Groundwater Transfer Review Summary Form

Transfer/PA # T- 13990

Application: T-13990

Applicant Name: Roy and Carolyn DeCrevel

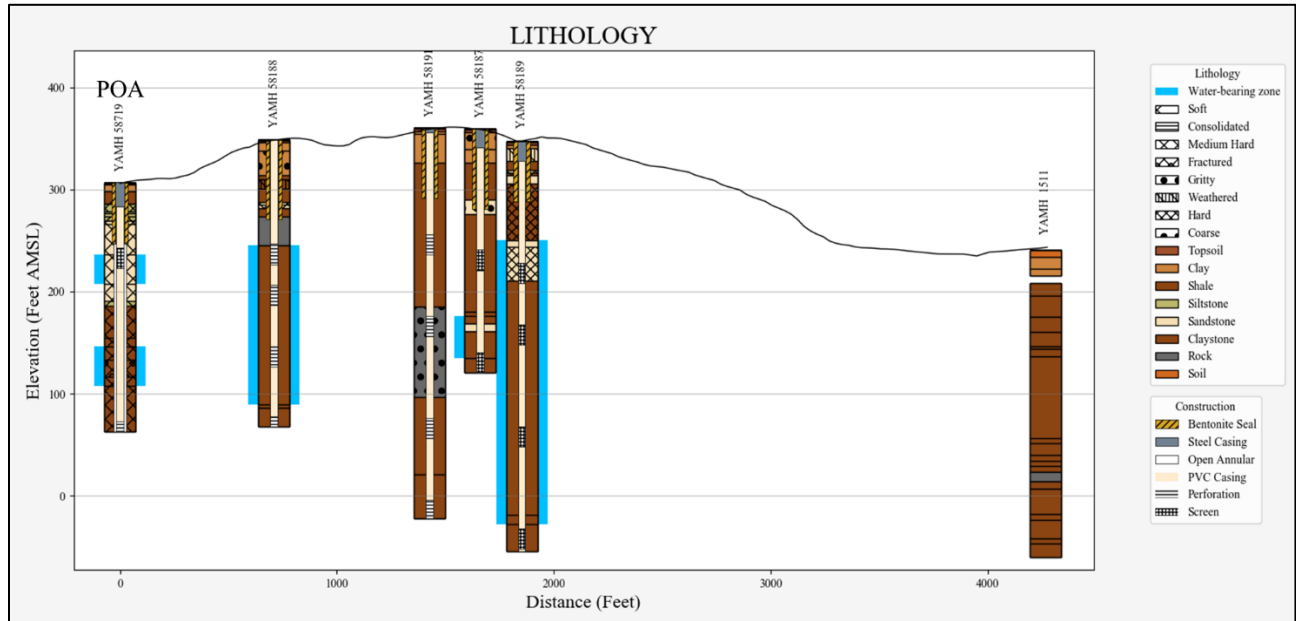
- b) If yes, would this proposed change, at its maximum allowed rate of use, likely result in another groundwater right not receiving the water to which it is legally entitled?
☐ Yes ☒ No If yes, explain: The applicant's right is senior to other rights to which it may interfere, and based upon water level data collected since 2019 (see attached hydrograph) is not anticipated to restrict access to groundwater for any neighboring right.

Cross-section showing relative depths and construction of proposed POA and nearby wells.

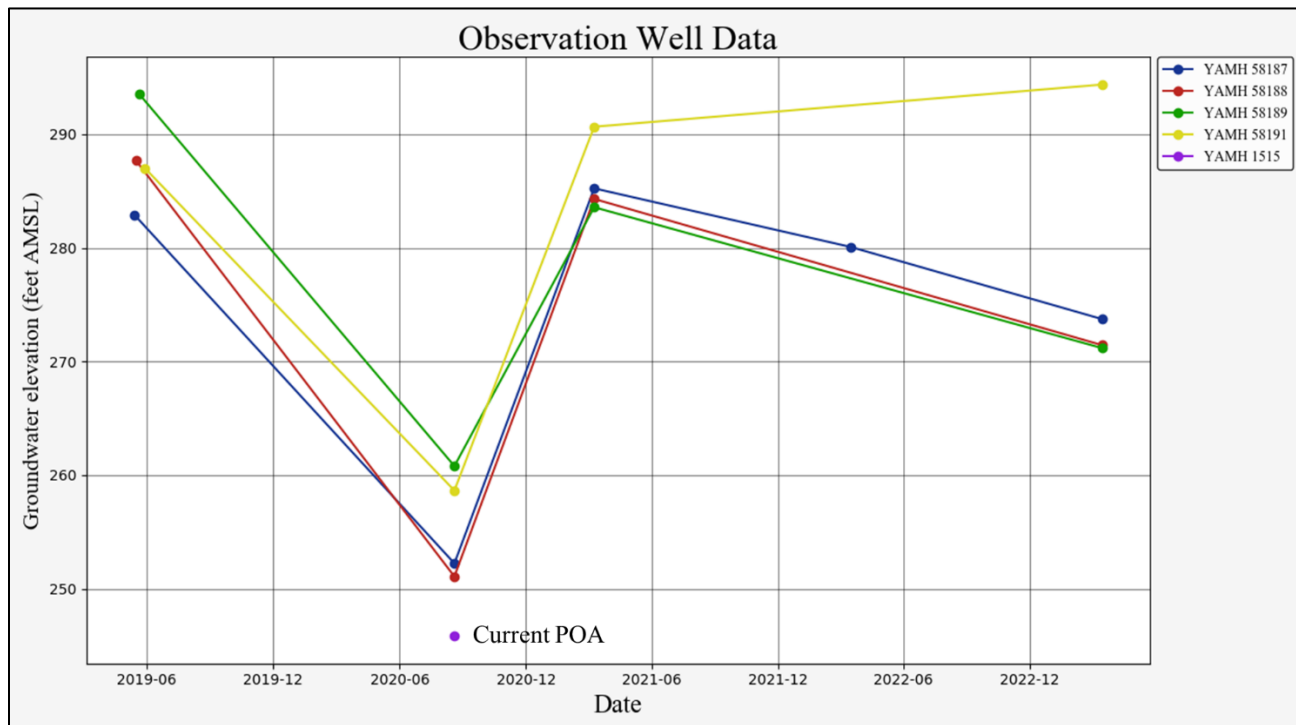
4. a) Will this proposed change, at its maximum allowed rate of use, likely result in an increase in interference with **another ground water right**?
☒ Yes ☒ No Comments: The proposed POA is not significantly closer to any other groundwater right. However, it is significantly deeper and more likely to increase interference to junior rights to the east that have heretofore interfered with the applicant's ability to fulfill their customary authorized water use.
